County of Fairfax, Virginia

STAFF REPORT ADDENDUM #2

SE 2014-PR-067

APPLICANT: Konstantin E. Panov

LANDSCAPE PLAN
LOT 1 WILLOW POINT
 PROVIDENCE DISTRICT
 FAIRFAX COUNTY, VIRGINIA

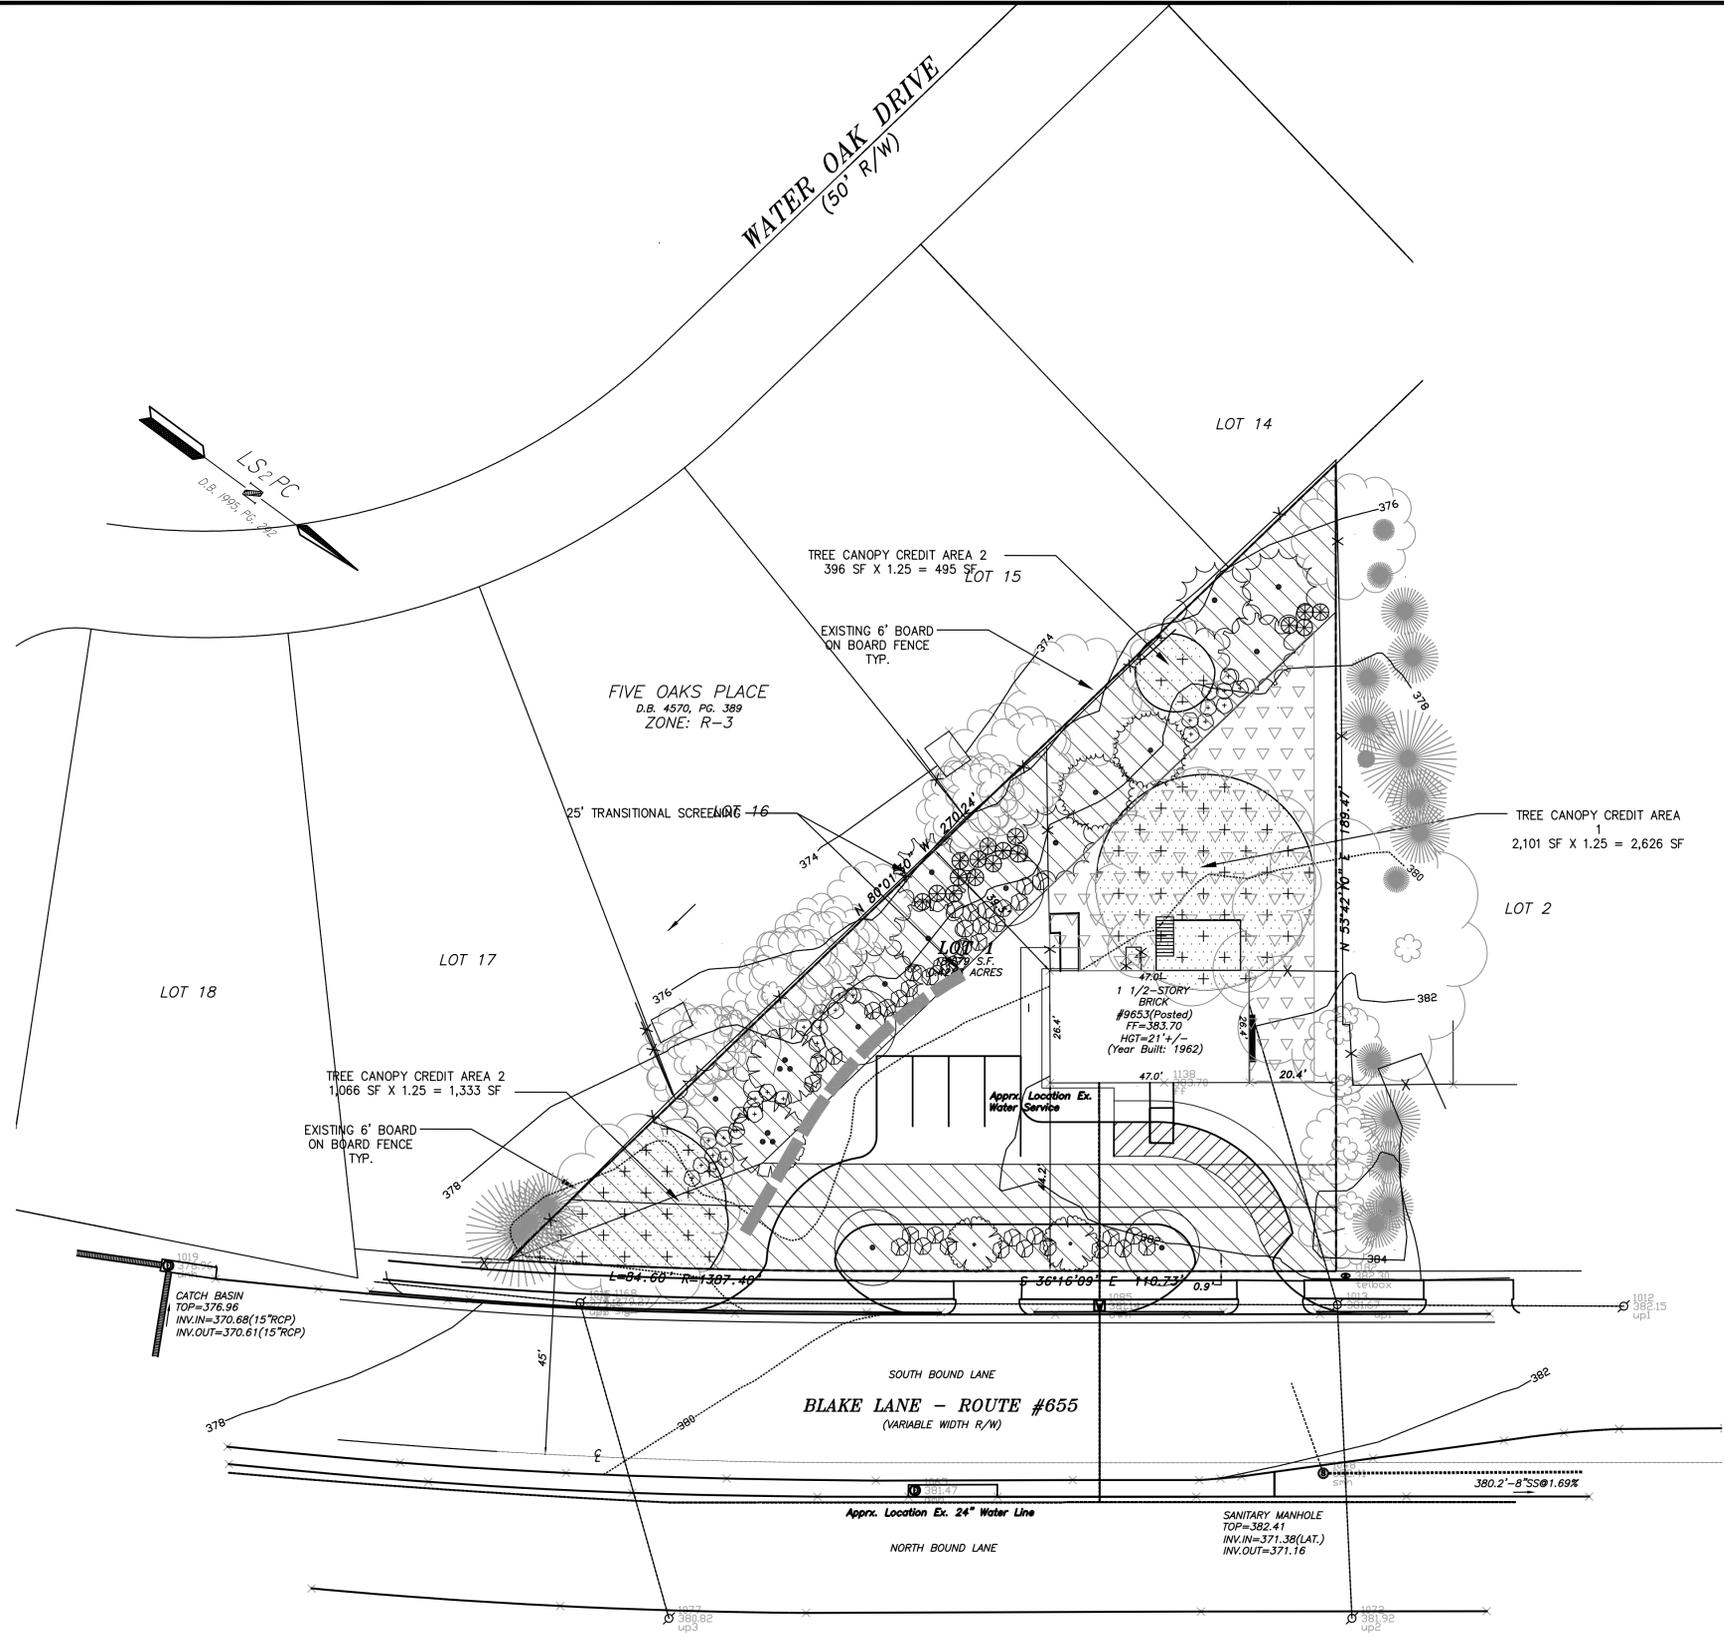
- 1. Comment:** The specific plant material proposed to be planted and to be used toward meeting the transitional screening requirement has not been provided. In addition, the legend on sheet 2 identifies the size of the proposed evergreen trees in caliper rather than in height.

- 2. Comment:** There appears to be an existing 15-foot wide public utility easement along the eastern property boundary, adjacent to Blake Lane, within the transitional screening yard. Trees shall not be planted within any existing or proposed public utility easement.

Recommendation: Provide the specific plant material proposed to be planted and to be used toward meeting the transitional screening requirement. Also, when using evergreen trees, the size is expressed in height, not caliper inches.

Recommendation: If trees are shown to be planted within an existing or proposed utility easement, the plan shall contain a letter of permission from the owner of the easement. Because the plants are part of the transitional screening requirements, a note on the plan should be provided that states “If any work occurs within the easement that causes damaged to or requires the removal of any plants associated with the transitional screening, they shall be replaced by the Applicant in the same sizes and quantities shown on the SE Plat within the current growing season.”
